## MEMORANDUM

**SUBJECT: BioEnergy Development Group, LLC  
BioEnergy Innovation Center  
Draft Permits: APC-2022/0048- CONSTRUCTION & APC-2022/0049-  
CONSTRUCTION  
1,451 HP (1,082 kW) Natural Gas-Fired Cummins Emergency Generator  
Anaerobic Digesters with Associated Flare, RTO, & Biogas Upgrade Equipment**

DATE: August 21, 2022

*Figure 1: Location of BioEnergy Innovation Center with Respect to Coastal Zone*

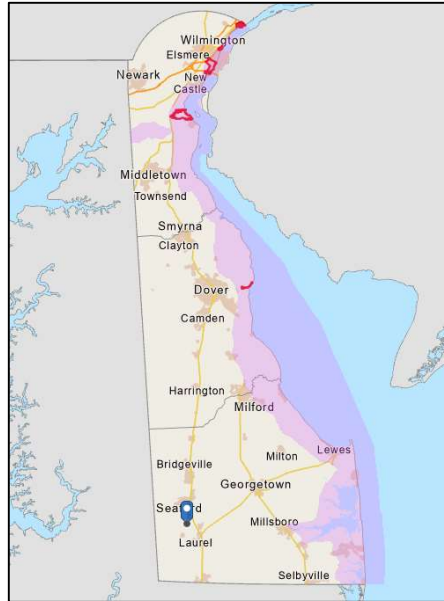
As Figure 1 illustrates, the proposed project would not be located within the Coastal Zone.

*Figure 7: Location of Liquid Feedstock Receiving Area*

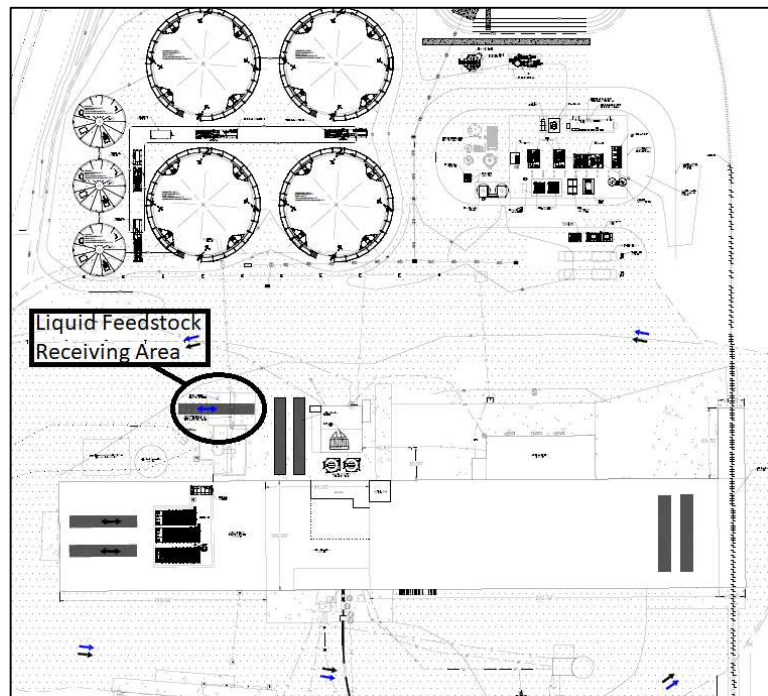
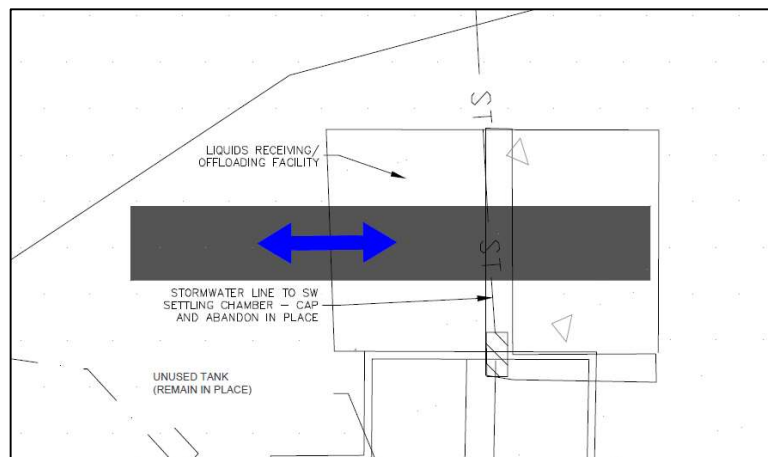
Figures 7 and 8 highlight the location of the liquid feedstock receiving area, as shown on the Proposed Facility Layout Drawing that was included in the application.

*Figure 9: Location of Solid Feedstock Receiving Area**Figure 10: Solid Feedstock Receiving Area*

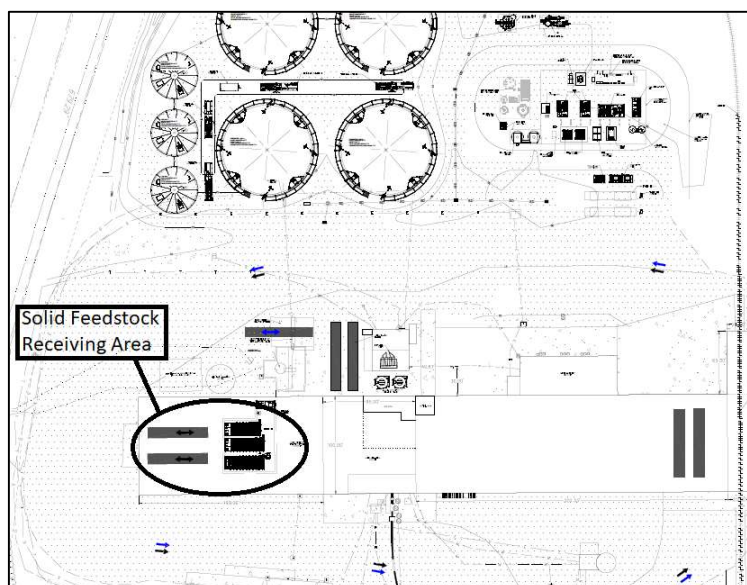
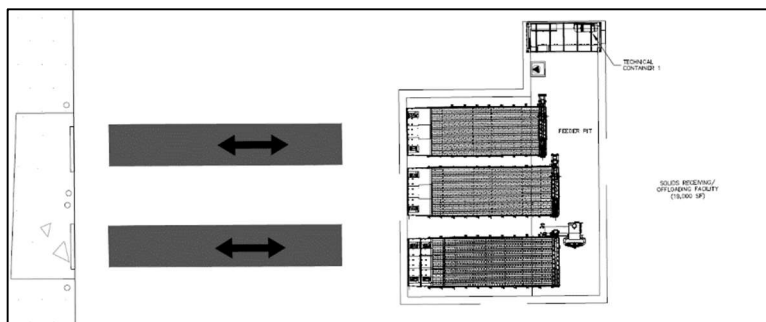
One item I had some concern about leading into this project was the potential storage of raw feedstock material and the odors that could be generated as a result. Based on the description of the liquid and solid receiving systems, it appears that material should be quickly transferred from the receiving areas to one of three (3) pre-tanks. Beyond quick material transfer, the Engineering Report provided the following information related to "Odor Control Equipment":

Based on this description, it is my understanding that the solid feedstock receiving building's odor control system is essentially control through dilution. In a March 30, 2022 letter to BioEnergy representatives I asked for, among other things, additional information related to the solid feedstock receiving operations. The questions initially asked (italicized) and answers provided (bold italicized) in BioEnergy's April 7, 2022, response letter are summarized below:

***The solids separation equipment is located in the building, which will have an overall exhaust system for odor control. The exhaust system will be sized appropriately for air flow in both the receiving area and the solid separation area. In the solid separation area liquid from the digesters flows to the solid separation feed tank which in turn feeds the disc press for the dewatering process. The disc press produces liquid and solid fractions. At this time, we do not plan to install filters on the solid separation tanks.***

Figure 19: Process Flow Diagram

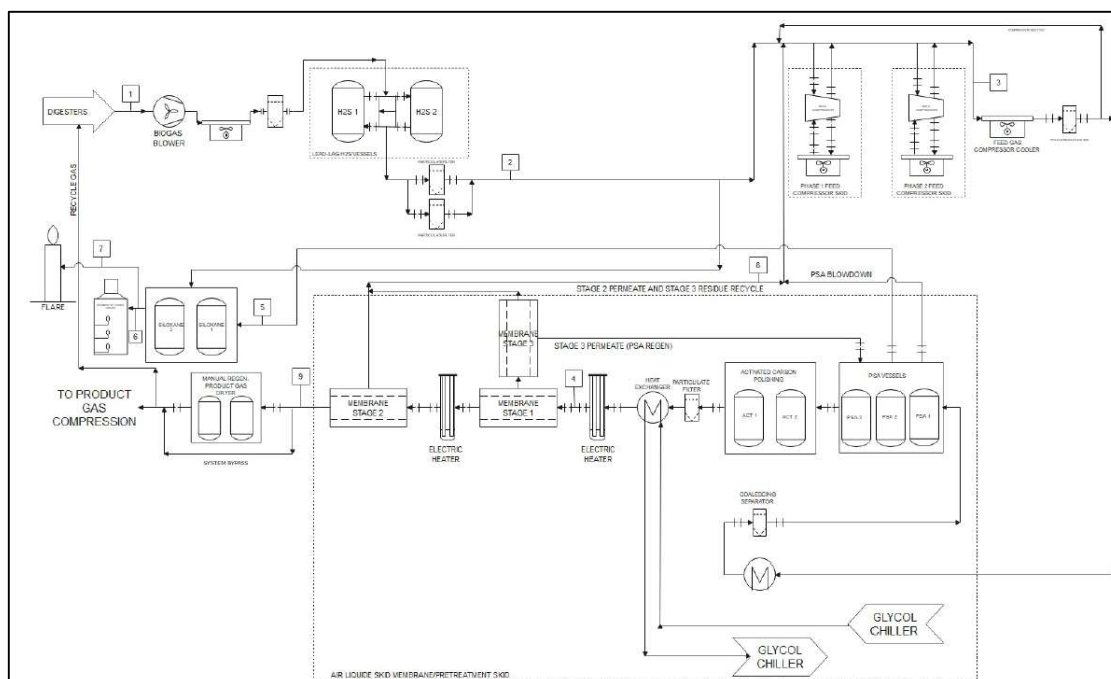
While the PFDs were helpful in understanding the flow, I wanted greater clarification on the potential paths through which the biogas would flow. In order to obtain that understanding, I requested “a narrative
